**Date:** June 6, 2012  
**To:** Retrofit and Performance Standard Expert Panels  
**From:** Tom Schueler, CSN  
**Re:** Watershed Technical Committee Response to the Final Reports

### Revision 1. Revising TN Adjustor Curve to Reflect Base flow Nitrate Movement in Urban Watersheds.

Figure 2. Revised TN Adjustor Curve

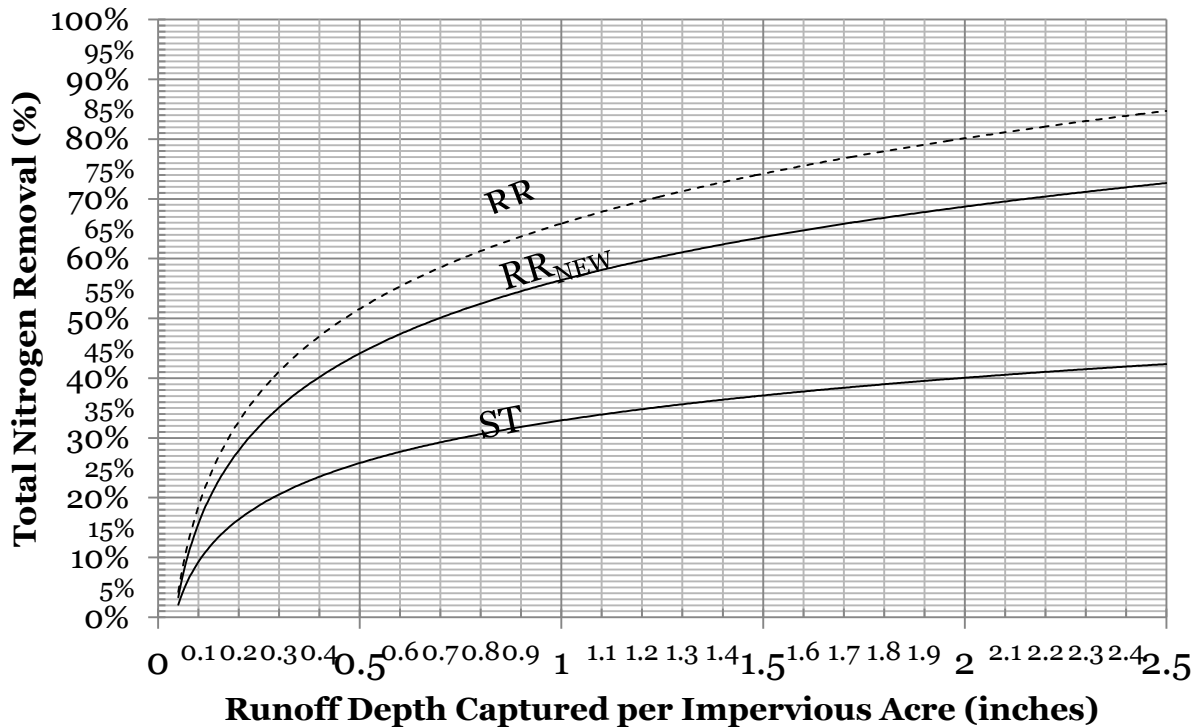
Given the inflow concentrations, the potential groundwater/under drain nitrate loss would be  $(0.3)(0.60) = 0.18$ , or a discount factor of 0.82

The discount factor is then applied to the anchor rates used to derive a new N adjustor curve. The anchor rate for RR practices would be adjusted downward from the current 70% to 57%, and the existing runoff frequency spectrum equation would be used to develop a new, lower curve for TN removal. An example of the how this discount influences the existing N adjustor curve is shown in Figure 2.

Figure 3: Proposed reduction Multiplier for TN removal Rate based on % pervious area into the drainage area to a retrofit or a new stormwater BMP

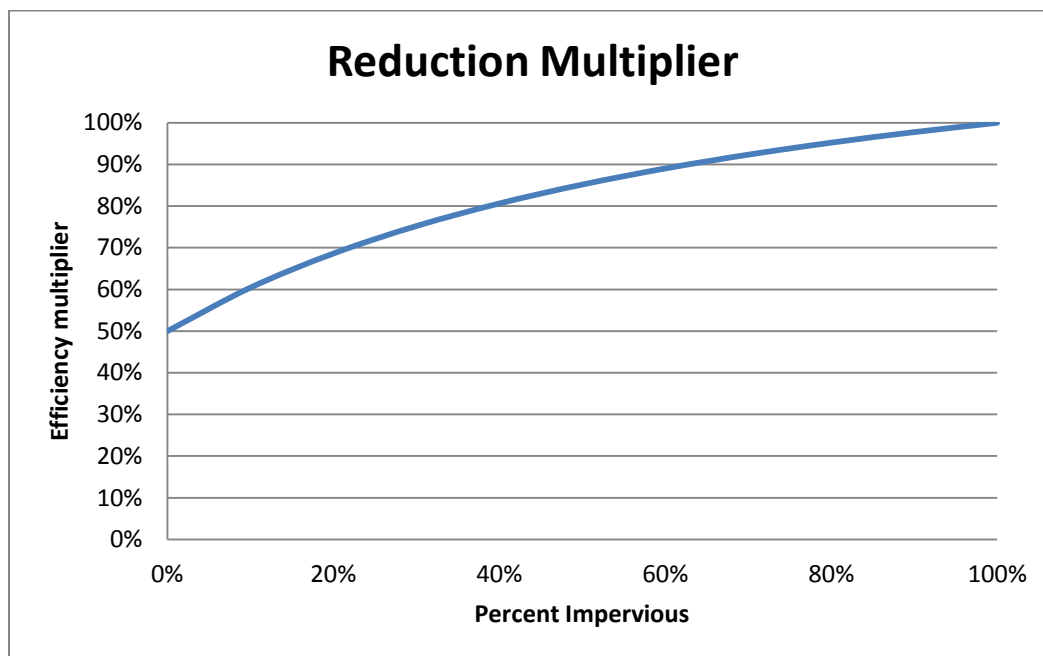
As shown in Figure 3, the multiplier would be 1.0 for a practice with a 100% impervious drainage area, and 0.5 for a facility that is 100% pervious. This multiplier is then used to adjust the removal rate determined from the new TN adjustor curve.

$$N_{adj} = RR_{NEW} \times (1 - P/2)$$

$$N_{adj} = ST \times (1 - P/2)$$

Where P = pervious fraction of site area

Figure 4: Baltimore County Stream Monitoring Data for Baseflow Nitrate and Total Annual Nitrogen Loads

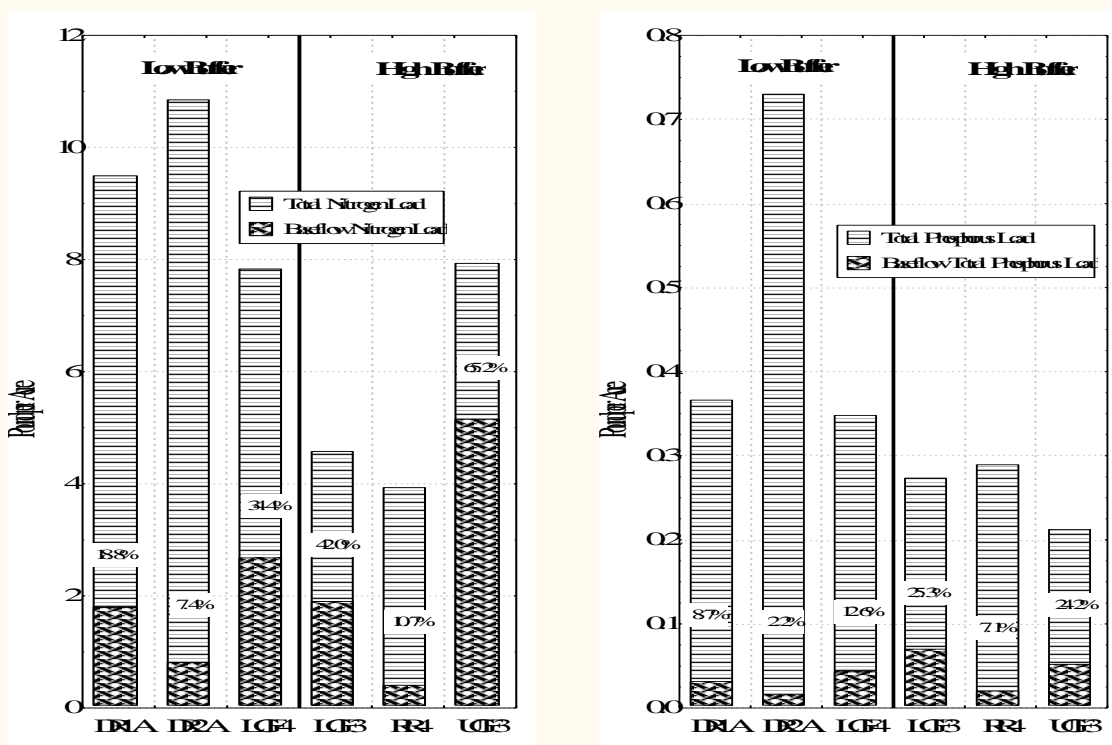
Some scientific corroboration of the Shenk modeling approach can be found in an analysis of urban stream nitrate loads taken from Baltimore county, which compare the ratio of baseflow nitrate loads to total annual loads (See Figure 4, will get the source, but I think it is Baltimore LTER)

If it conservatively assumed that all of the base flow nitrate monitored in urban streams represents untreated base flow, and the ratio of the annual base flow nitrate load to total annual stream total nitrogen load represents the discount factor. These watersheds are in the 25 to 50% IC range, so the average ratio of baseflow nitrate to total nitrogen load of around 20 to 30% is reasonably consistent with the Shenk multiplier equation (the one stream value of 54% is an outlier, and appears to reflect the impact of dry weather sewage discharges via illicit discharges and/or sanitary sewer overflows).
